**RE: Removal Action Work Plan (RAWP)
Former WPSC Green Bay Manufactured Gas Plant Site, Green Bay, Wisconsin
Wisconsin Public Service Corporation
CERCLA Docket No. V-W-06-C-847, CERCLIS ID – WIN000509948, BRRTS # - 02 05
000254**

Wisconsin Public Service Corporation (WPSC) is submitting the attached Addendum No. 1, Revision 0 to the Early Removal Action (ERA) Work Plan - Revision 2 for the Green Bay Former Manufactured Gas Plant (MGP) Site, Wisconsin Public Service Corporation (WPSC), Green Bay, Wisconsin.

To: Frank Dombrowski and Glenn Luke - WPSC
From: Abby Small and Julie Zimdars – Ramboll
cc: Staci Goetz - Ramboll
Re: Early Removal Action Work Plan Addendum No. 1, Revision 0
 Green Bay Former Manufactured Gas Plant, Green Bay, Wisconsin
 Wisconsin Public Service Corporation
 CERCLA Docket No. V-W-06-C-847, WDNR BRRTS # 02-05-000254,
 CERCLIS ID – WIN000509948

ATTACHMENT B – UPDATED SHEETS C-090 AND C-100

C-100

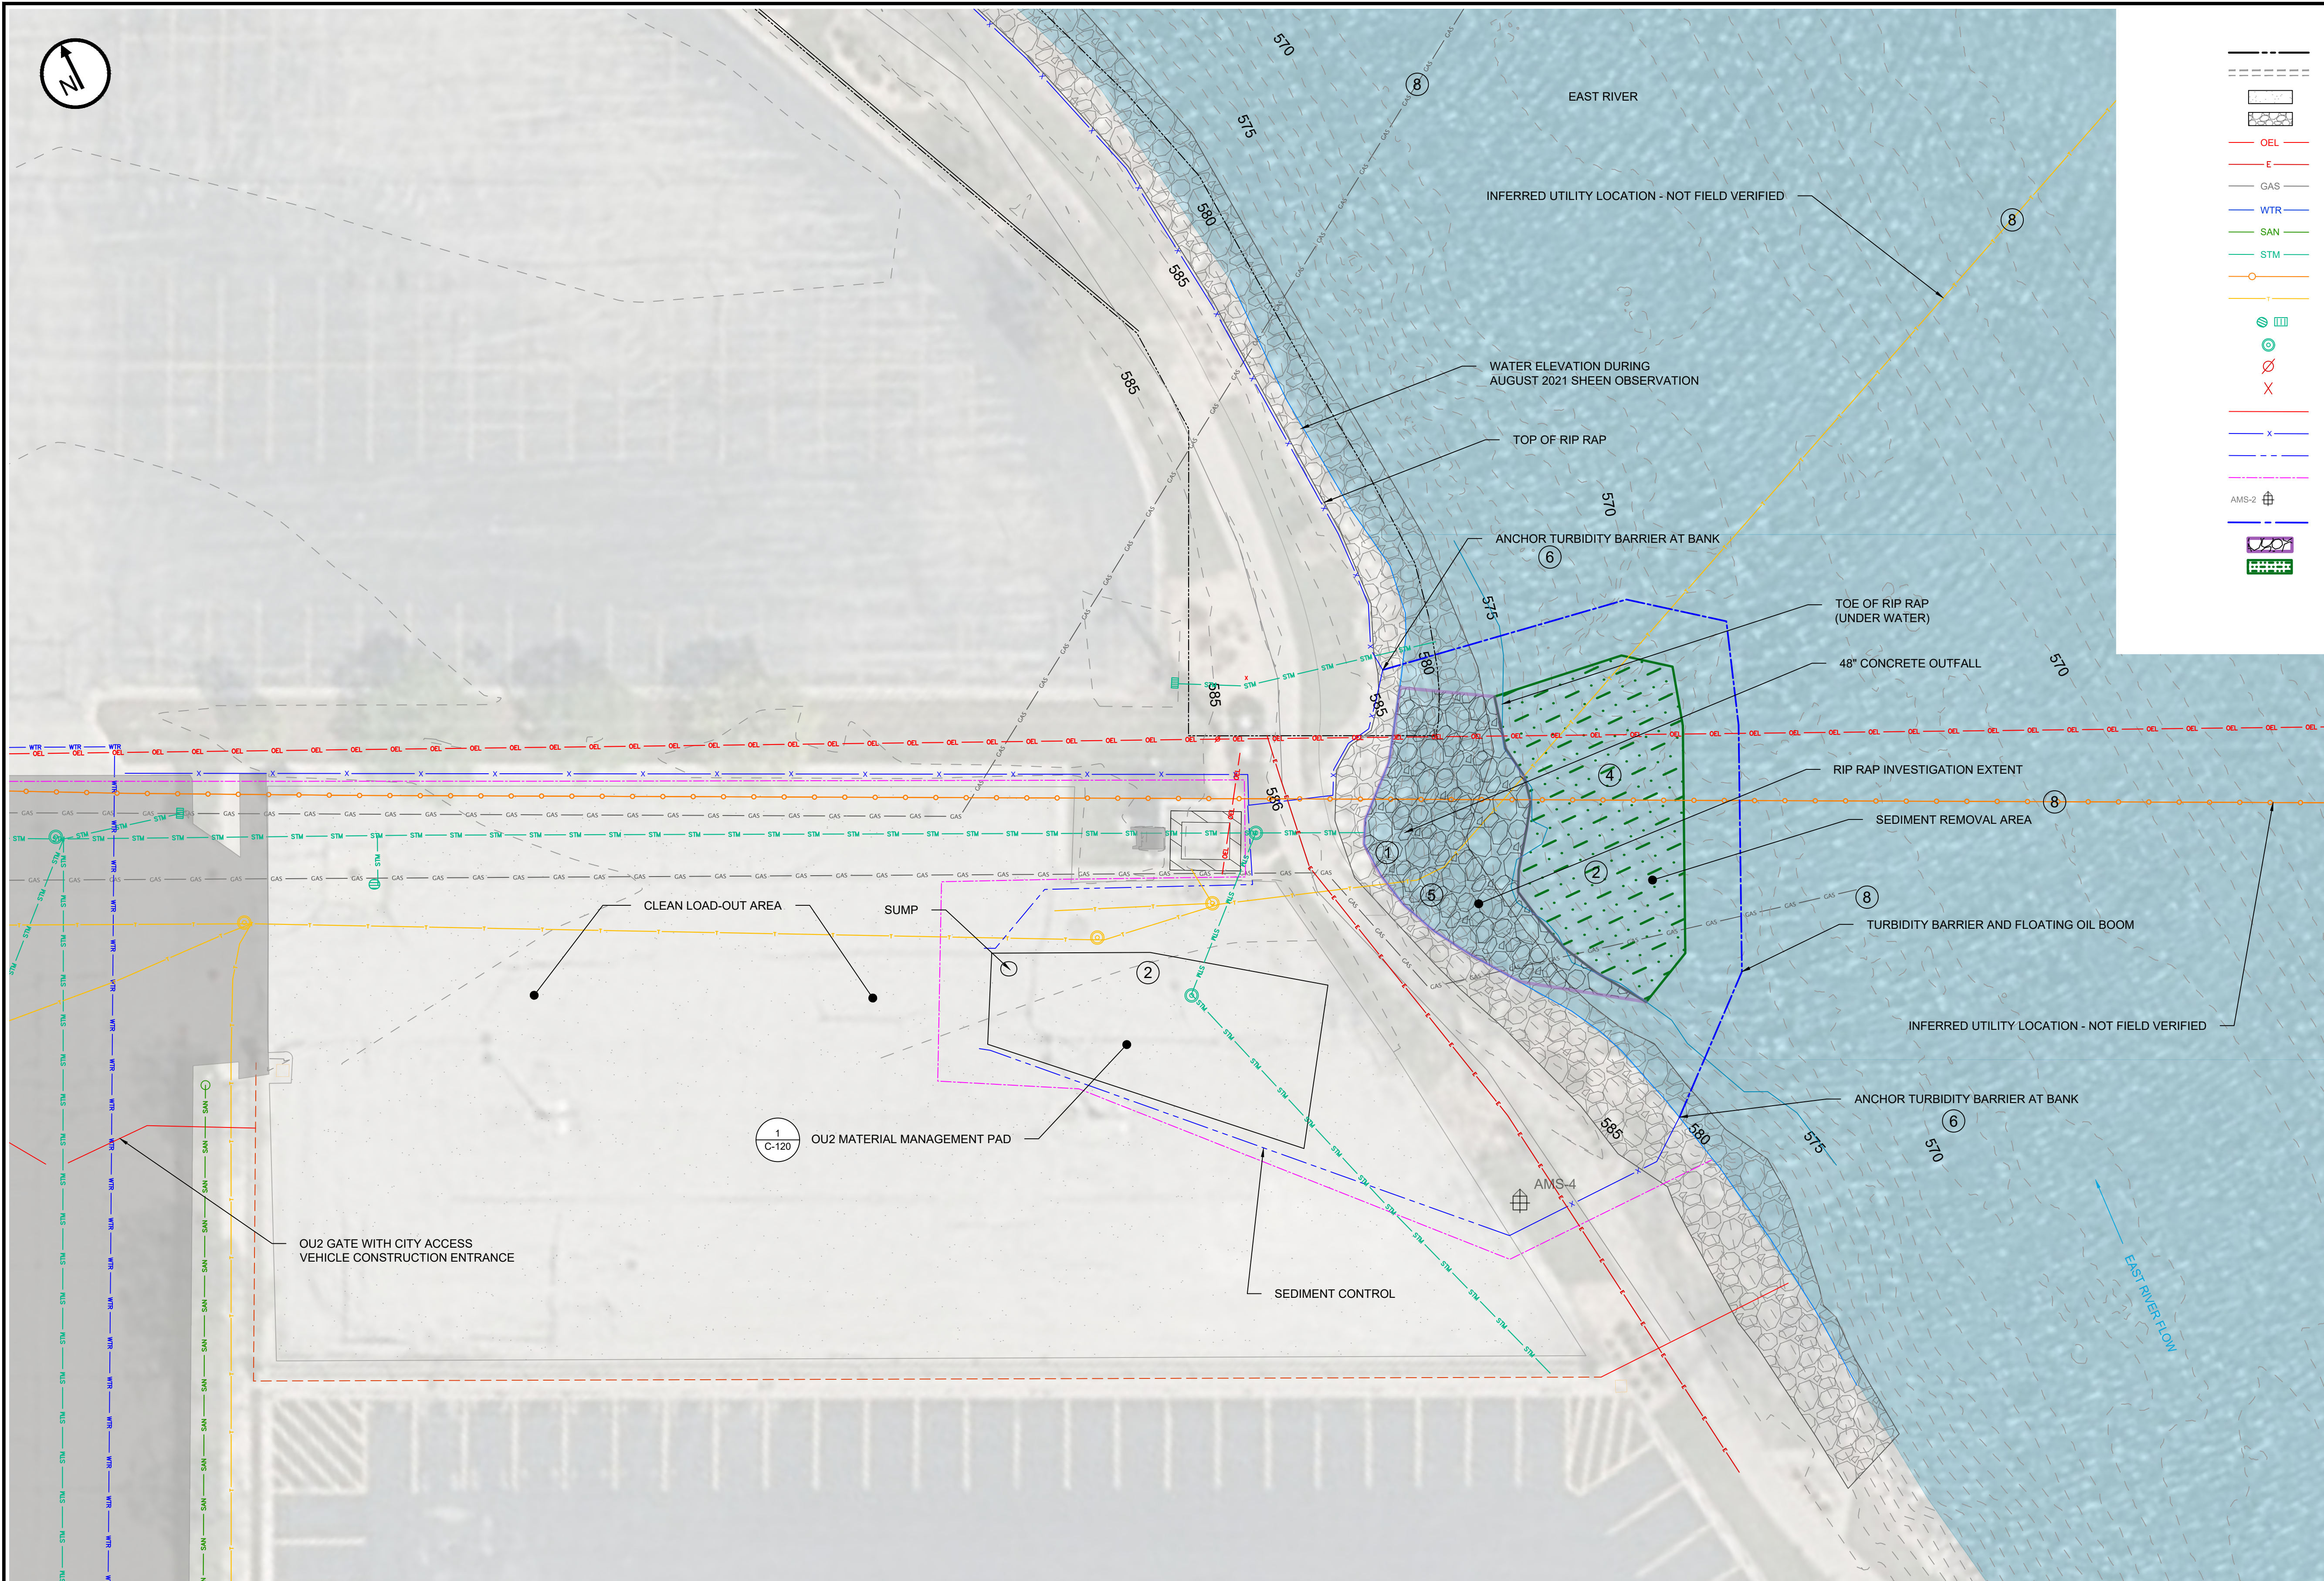
Saturated, soft in-channel sediments will be removed from within the Sediment Removal Area as shown on Sheet C-100. The removal extent is based on observations of sheen generated during sediment probing activities, soft sediment thickness observations measured by poling activities, and sediment sampling analytical results as presented on Figure 4 of the ERA Work Plan. All soft sediment within the lateral extent will be removed down to the underlying native clay bottom. Saturated sediments will be staged on MMP and gravity-dewatered and amended with a drying agent (e.g., Portland cement or calciment) as needed to meet landfill disposal requirements.

- CONTRACTOR NOTES:**
1. Remove 6 inches of bank soil material and all soft sediment below riprap removal area.
 2. Remove all soft sediment to hard bottom (approximately 6" to 18" thick), as directed by Engineer, in designated sediment removal area. Transport to material management pad for dewatering, drying and mixing to acceptable dried conditions for transport to the landfill.

3. Utility off-sets may require contractor field adjustments to the removal extent.
 4. Backfill area with imported pea gravel from commercial quarry in areas and to elevations approved by Engineer.

5. Place and anchor geotextile fabric on bottom and backfill riprap area with gravel from commercial quarry. Carefully replace riprap to similar sizing and configuration, elevation and location as previous.
